UNITED STATES PATENT AND TRADEMARK OFFICE

10/797,449

<p align="center">Office Action Summary</p>	Application No. 10/797,449	Applicant(s) OSBORNE ET AL.	
	Examiner Cheryl Miller	Art Unit 3738

DETAILED ACTION

Attachment #1 (marked up)

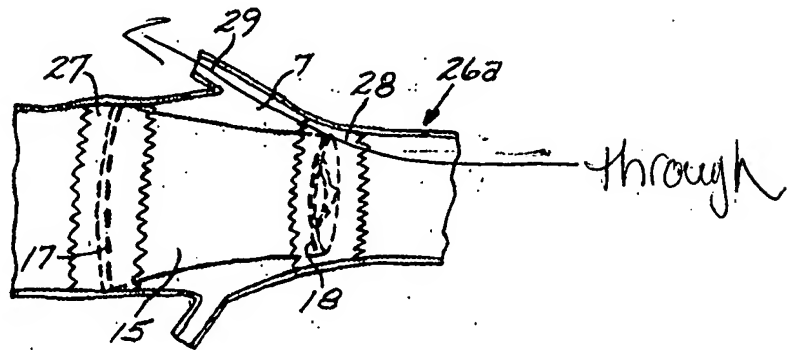
Applicants have argued that Duran et al. (US 7,125,418 B2) does not disclose an opening that permits a controlled amount of fluid flow to pass through the medical device in a second direction. The examiner disagrees for several reasons. First, the ability for the opening to allow fluid to pass is functional language and is dependent upon the size of the vessel in which the device is placed. When placed in a large vessel (which Duran's device is capable of doing), the leaflets will not make a complete seal with the vessel wall and thus permit some blood therethrough. Thus, Duran's device is *capable* of allowing some blood through, this is dependent upon the use, whether the device is placed in a large or small vessel, *it is capable of being placed in a large vessel in which fluid would pass therethrough*. Second, as seen in figure 9 for example, blood is capable of traveling *through* the device, between the stent and leaflets, into the branch vessel, see attachment 1. Third, applicant has not defined the term "through" and therefore it is given its broadest plain meaning, for instance: between or among the individual members or parts, within the limits of, extending from one surface to another, see www.dictionary.com, and Merriam-Webster's collegiate Dictionary, 10th edition, 2001. Therefore, since blood travels along parts of the medical implant (see attachment 1, fig. 11A), it thus is considered to travel *through* the implant.
